### PRODUCT ADVISORY LETTER NO.: CU46-19002

**AFFECTED PRODUCT(S):** UPLC-II

**AFFECTED MODULE(S):** Front Aux Display Card CU20-DP1A3-001 Rev. 3 or lower (on white label) that shipped before 4/8/2019. If labeled Rev 3, some boards still may not need the change as a long visible green wire jumper was added to the top of the board. We recommend trying to measure continuity (<2 ohms) between the front ethernet port metal shell and any screw on the metal chassis. If there is no continuity, then you need this upgrade, otherwise you don't.

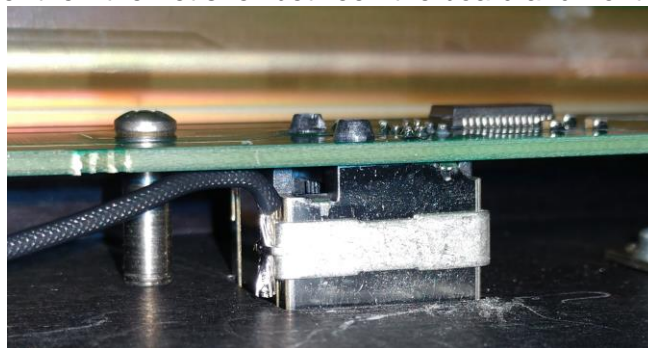
**SYMPTOM(s):** The front panel Ethernet metal shell is susceptible to Electrostatic Discharge (ESD). If enough static charge is applied the Display will reset and may show odd characters temporarily. Also, the four front LEDs may indicate incorrectly.

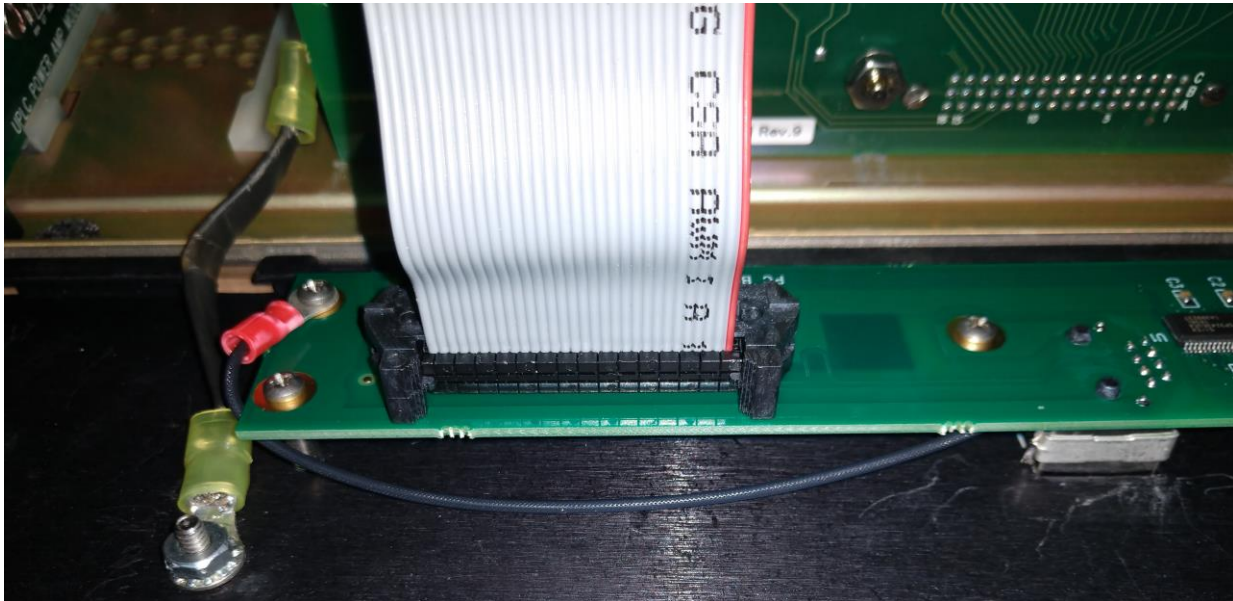
**TECHNICAL DETAILS:** The Ethernet metal shell is ungrounded. This allows ESD to travel from the Front Aux Display Card to the main Front Display card and cause a display reset. This reset only affects the display and the **TX RF ON** LED which in units set in the On/Off mode will erroneously illuminate without the unit transmitting. This LED will correctly reset to normal when the unit transmits.

**CORRECTIVE ACTION:** Call AMETEK Power Instruments Customer Services at **800-785-7274** to request an ESD grounding cable # 1089-209 for each UPLC-II that needs to be corrected. This modification is available at no charge and will not affect any applicable warranty.

- Ensure that the protection scheme using the UPLC/UPLC-II at the substation is locked out. \*
- Open the Front Door.
- Power off the UPLC-II by pulling the Power Supply card or other external method if available. \*
- Snap on the clip over the Ethernet shell between the board and front door.

*\* (If needed, the unit can be kept in service, and this can be done without powering down. Care should be exercised to prevent accidental shorts against the PC board with the jumper.)*

- Unscrew the one board support screw (shown in top left corner of board) and route the wire under the board, around the post and back up to the top board screw (per the pictures below).

- Attach the lug using the board support screw.
- Re-power the unit per your procedures.
